Melton East
WURUNDJERI COUNTRY
PRECINCT STRUCTURE PLAN

Co-design Workshop
Summary

APRIL 2023

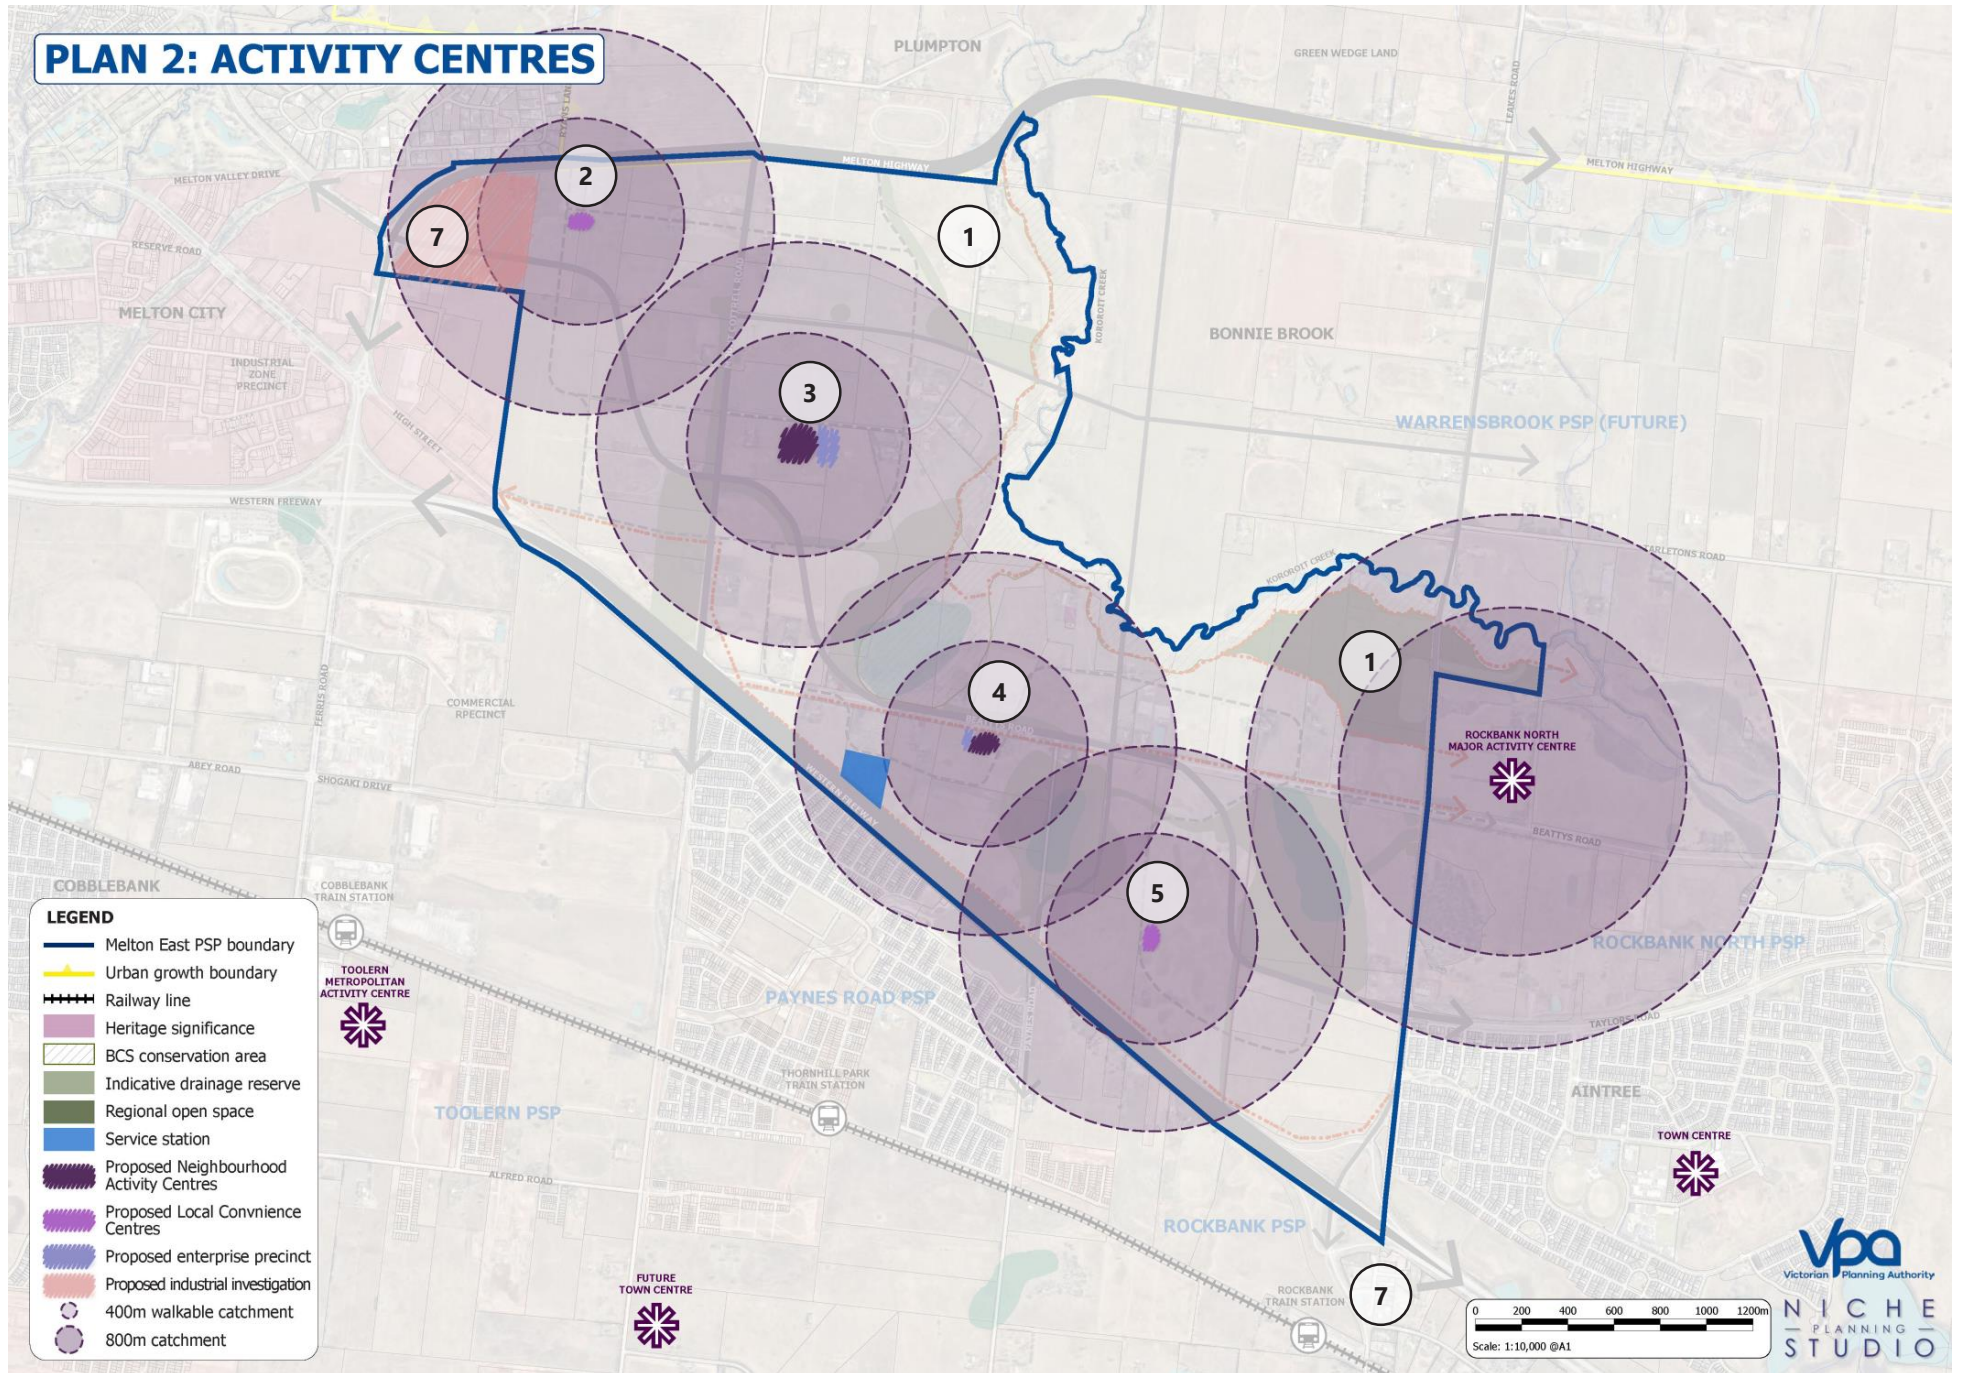
ITEM	DISCUSSION
1	General
	<ul style="list-style-type: none"> Roads should be dispersing cars out to the arterial roads. 90 degree turns should be considered for Taylors Road at Leakes Road and Mt Cottrell Road rather than one large continuous road. Preference to use existing road reserves. Plan presents major issue with school access and parking. Schools will require local access roads. Schools may have issues being located next to major arterial road. North-western corner of PSP creates two divided communities between existing industrial area and future residential area. Plan should consider whether rat-running from northern Melton to Western Freeway on-ramps might occur. Does not clearly support 20 minute neighbourhoods. Consider interface with Urban Growth Boundary. There is a strong link to High Street. Needs to have stronger north-south connections. Concerns raised with ICP costs of two creek crossings.

ITEM	DISCUSSION
2	Taylors Road alignment
	<ul style="list-style-type: none"> Dissects the precincts and disjoints residential communities. Diversion from conservation area is good. Proposed alignment allows movement from east to west as quickly as possible but does not create a connected community. Seems squeezed into the precinct as there is no PSP planning to the north-east. 'Z' shape connection is unfavourable in the north-west of PSP. Should be mindful of freight on arterial road. Curvilinear shape of proposal compromises integrity of the grid. Consider a cross-section that provides higher amenity than a standard arterial road.
3	Beattys Road
	<ul style="list-style-type: none"> Should be unique to differentiate from Taylors Road. Requires stronger connection west of Leakes Road. There is opportunity for a more central alignment and to be part of the arterial grid west of Leakes Road.
4	North-south connector roads

<ul style="list-style-type: none"> Need to plan for the PSP to the north of Kororoit Creek. Further investigation required for Paynes Road and Western Freeway overpass. Mt Cottrell and Western Freeway overpass/interchange required; should be a priority connection as there is a risk of bottleneck.

ITEM	DISCUSSION
5	Active & public transport
	<ul style="list-style-type: none"> • Plan should show proposed pedestrian link/shared paths across freeway. • Plan does not articulate shared path access to major railway stations. • Supportive of shared path running through centre of PSP. • Shared paths from within PSP should continue to railway stations. • Current issues with parking and bus frequency at Thornhill Park. • Walkability catchment of schools need further investigation. • Plan demonstrates good bike connections to community centres and schools, and to wetland/drainage reserves. • Bus connections to train stations should be established. • Busy intersection for shared paths at Beattys Road and Leakes Road. • Not as many shared paths shown in north-west portion of PSP.
6	Bridges
	<ul style="list-style-type: none"> • Logical locations of bridge creek crossings shown on plan. • Favourable that there are not too many bridges required.

ITEM	DISCUSSION
1	General
	<ul style="list-style-type: none"> • Consider active main streets. • Add/consider connections to drainage reserves. • Potential for more east–west connections to destinations other than Melton Highway and Western Freeway. • Potential for roads to follow cadastre more closely. • Consider flood immunity. • Consider existing community connections to Thornhill Park. • Melton Highway requires four lanes, it is currently very busy and dangerous. • Early delivery of town centre allows for walkability. • Consider downgrading six lane roads through the PSP and use north–south roads instead. • Minimise irregular land parcels dissected by road connections. • Requires better forward planning for the entire integrated transport network. • Developers would like to investigate different cross sections that might also support the PSP 2.0 density targets.

ITEM	DISCUSSION
2	<p>Taylor's Road alignment</p> <ul style="list-style-type: none"> • Consider realignment to be less divisive. • Use north-south roads to connect to freeway rather than bringing Taylor's Road through the PSP. • Potential for road to not directly adjoin conservation area. • Alignment can be simplified. • Look at functionality of the four and six lane roads. • Alignment to use Beattys Road reserve east of Mt Cottrell Road. • Tarletons Road to connect through to Federation Drive.
3	<p>Beattys Road</p> <ul style="list-style-type: none"> • Opportunity to use Beattys Road for Principal Public Transport Network (PPTN) route. • Use existing Beattys Road reserve.
4	<p>North-south connector roads</p> <ul style="list-style-type: none"> • Crossings should be bus capable across freeway. • Diamond interchange for Mt Cottrell Road and Western Freeway intersection.
5	<p>Active & public transport</p> <ul style="list-style-type: none"> • Ensure there are shared path connections to the freeway, town centre, train stations and schools. • Accommodate a high-capacity bus route on Taylor's Road. • Cycling network to align along the outside of seasonal herbaceous wetland. • Need bike network connection up to northern activity centre. • Bus connections to schools and community facilities. • Potential to upgrade existing train line. • Bike paths could be on both sides of drainage areas.

ITEM	DISCUSSION
6	<p>Bridges</p> <ul style="list-style-type: none"> • Potential for pedestrian bridges over Kororoit Creek, separate from road bridges.

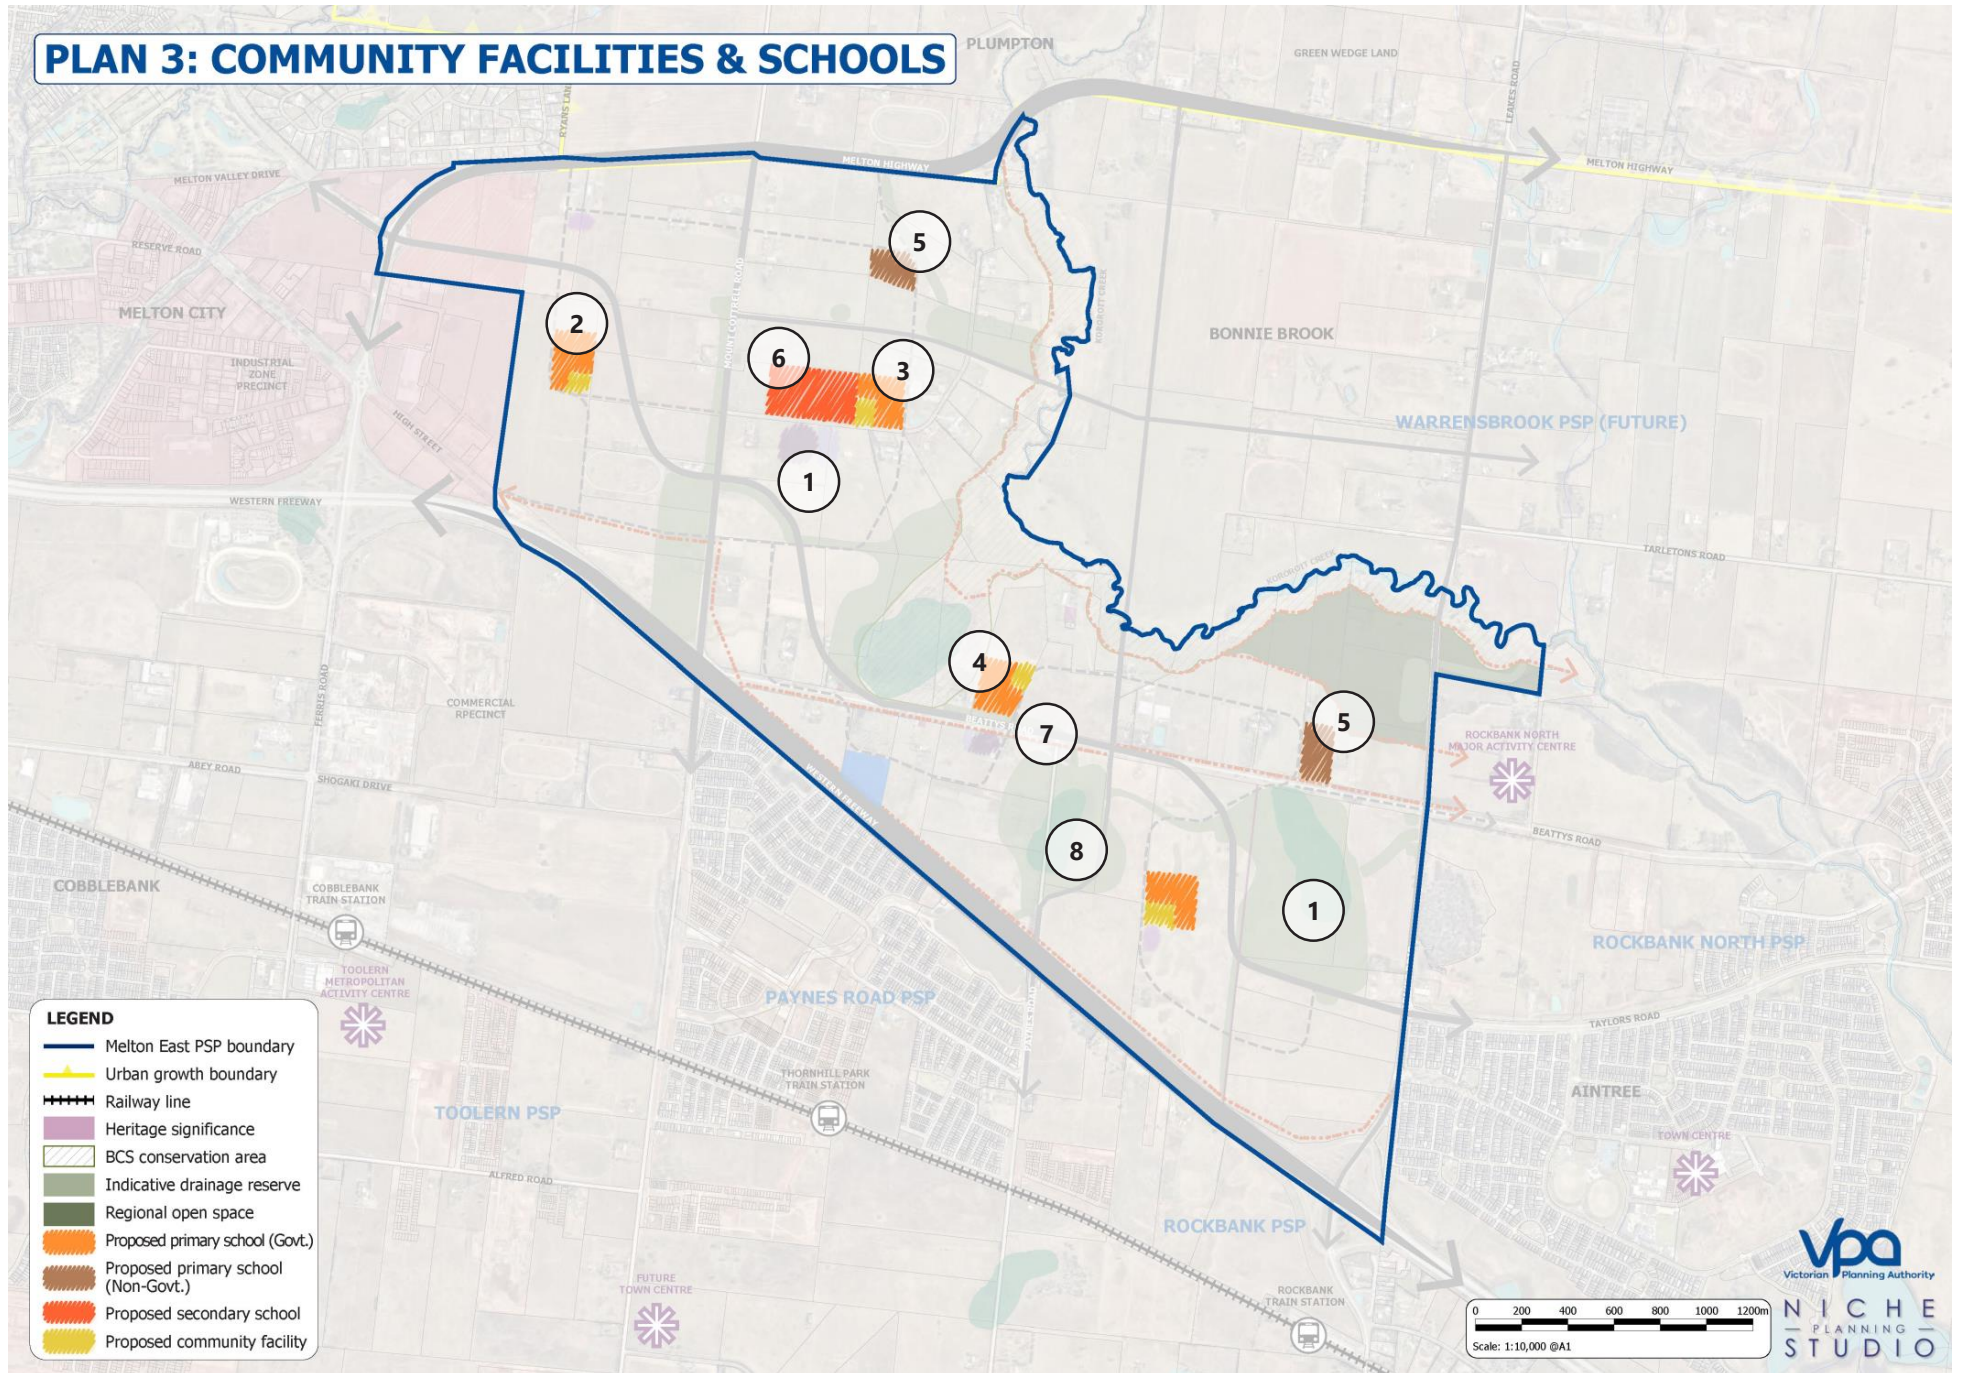
ITEM	DISCUSSION
1	General
	<ul style="list-style-type: none"> • Good number of centres and attempt at distributing catchment. • Appears to be big overlap in walkable catchment across drainage areas. • Should utilise amenity offered by regional open space and ensure there is active transport access. • Early delivery of activity centres will be beneficial and encourage more visibility to centres. • Consider connections to public transport and traffic volume/ movement around activity centres. • Northern section of the PSP is outside an activity centre walkable catchment. • Concerns about bottlenecks to activity centres. • Smaller centres allow response to changing retail demand. • There is good separation between larger centres. • Dislike roads interfacing activity centres, roads should not dissect through. • Location of town centres near arterial roads can result in a negative car parking interface. • Activity centres are not aligned sufficiently with objectives of the guidelines and site constraints. • Preference for centres to be located on single land parcels.

ITEM	DISCUSSION
2	North-western local convenience centre
	<ul style="list-style-type: none"> • Requires a bike network up to northern activity centre.
3	Mt Cottrell Road neighbourhood activity centre
	<ul style="list-style-type: none"> • Reconsider benefits of locating the activity centre on Mt Cottrell Road: <ul style="list-style-type: none"> – Maximised commercial outcomes and exposure. – Potential issues with traffic due to high activity near school. • Should be of a similar scale to Rockbank North activity centre. • Mainly drainage reserve in catchment.
4	Beattys Road neighbourhood activity centre
	<ul style="list-style-type: none"> • Amenity issues on arterial road and catchment access limited by road and drainage. • Need to consider access to use and any implications of existing service station.
5	South-east local convenience centre
	<ul style="list-style-type: none"> • Open up amenity to dry stone wall and drainage reserves. • Big overlap between this LCC and Beattys Road NAC. • Address relationship between central activity centre and this LCC.

6	Housing
	<ul style="list-style-type: none"> • Agree with dwelling diversity and density around walkable catchments. • Rear-loaded housing product is not always suitable, viability issues. • PSP offers good densities: <ul style="list-style-type: none"> – Standard: 20 dwellings per hectares – High: 30 dwellings per hectares

ITEM	DISCUSSION
7	Land use
	<ul style="list-style-type: none"> • Rockbank Station in a ‘desert’ zone where there is no walkable access to centres. • Potential to redevelop Rockbank train station. • Generally supportive of SLEPs. • Questions surrounding SLEPs: <ul style="list-style-type: none"> – What is the parking/traffic interface with SLEPs? – Is a master plan or concept plan needed? – Are there any guidelines and/or standards? – Adaptability/longevity concerns. • Accepting that industrial investigation area is a natural extension of existing industry, however it offers poor amenity.

ITEM	DISCUSSION
1	General
	<ul style="list-style-type: none"> • Potential for a LCC on Paynes Road. • Connect Cobblebank Hospital to town centres (future). • Potential for restricted retail on Leakes Road. • Explore bike lane from waterways connecting to activity centres. • Need more diverse cross sections to accommodate: <ul style="list-style-type: none"> – Services – Trees – Crossovers – Active transport – Bins – Visitor parking. • Co-locate essentials to support climate resilience and utilise available green assets. • Make amenity and destination-based town centres that are multi-functional. • Co-locate activity centres with pocket parks. • There are some areas of the PSP not within a walkable catchment. • Need to consider connections with Warrensbrook PSP.

ITEM	DISCUSSION
2	North-western neighbourhood activity centre
	<ul style="list-style-type: none"> • Co-locate with community facility and parks. • Move further west towards creek, as catchment loses area in the industrial land. • Move south to be closer to open space and primary school.
3	Mt Cottrell Road neighbourhood activity centre
	<ul style="list-style-type: none"> • Potential for more mixed use and allow better day–night activity. • Relocate onto an arterial and allow for more passing trade, perhaps the intersection of Mt Cottrell Road and Tarletons Road. • Create a linear corridor connecting schools and open space towards the creek. • Move north-east to locate on connector road.
4	Beattys Road neighbourhood activity centre
	<ul style="list-style-type: none"> • Potential relocation to north of Beattys Road, on connector road and activating open space and conservation area. • Consolidate land uses in pocket north of Beattys Road.

5	South-east local convenience centre
	<ul style="list-style-type: none"> • Move east and locate on Leakes Road to allow for more passing traffic and exposure – NAC and LCC need arterial road exposure. • Shift to Paynes Road to support Paynes Road PSP and reflect LCC location on Leakes Road. • Move slightly south-east, improve road connection to Woodlea.
6	Housing
	<ul style="list-style-type: none"> • Consider higher density with amenity and commercial activity for Beattys Road NAC. • Potential for retirement living and social/affordable housing adjacent to town centres.

ITEM	DISCUSSION
	<ul style="list-style-type: none"> • Link to green corridors to make the most of central wetland and open space, further supporting medium density and 20 minute neighbourhoods. • Considerations for social housing within 800m catchment: <ul style="list-style-type: none"> – Delivery – Location – Incentive – Private/public • Urban design guidelines for 3 storeys residential, integration with character and superlots. • Potential for density near Rockbank Station catchment.
	<p>7 Land use</p> <ul style="list-style-type: none"> • Consider mixed use zoning within activity centres i.e., apartments over shops. • Diversity of local shops at town centres, to be linked to density. • Include retail floorspace in PSP for activity centres. • Consider mixed use zoning in industrial investigation area. • More guidance for developers on purpose and function of SLEPs. • Concept/master plans for SLEPs to consider: <ul style="list-style-type: none"> – Interfaces in detail – Longevity of the centres and if SLEPs are able to be adapted over time.
